Photo Report
Palmer Park
Programs, Services, and Activities

Finding: Palmer Park, located at 610 East Palmer in Glendale California, was inspected by Disability Access Consultants, Inc., on June 12, 2007.

Palmer Park

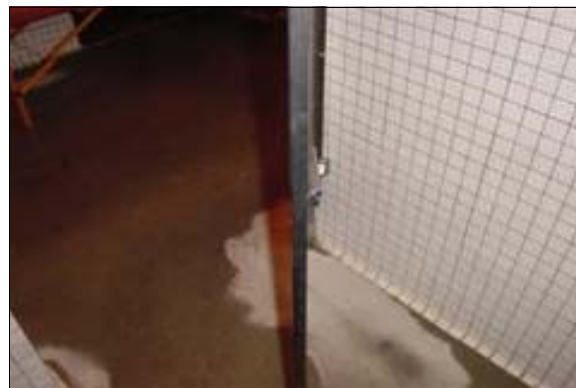
Finding: The door to the stall designated to be accessible in the restroom does not close automatically or have accessible hardware.

Full Rec: Provide an automatic door closer, spring hinge, pull bar or accessible handle mounted on the inside of the stall door to the stall designated to be accessible in the restroom (see ADAAG A4.17.5). Accessible hardware on the inside and outside of the stall designated to be accessible door shall be equipped with a loop or U-shaped handle mounted immediately below the latch. The latch shall be flip-over style, sliding or other hardware not requiring grasping or twisting. Make certain that the inside and outside door hardware is mounted no more than 48 inches above the finished floor (see CBC 115B.7.1.3 and ADAAG 4.13.9).
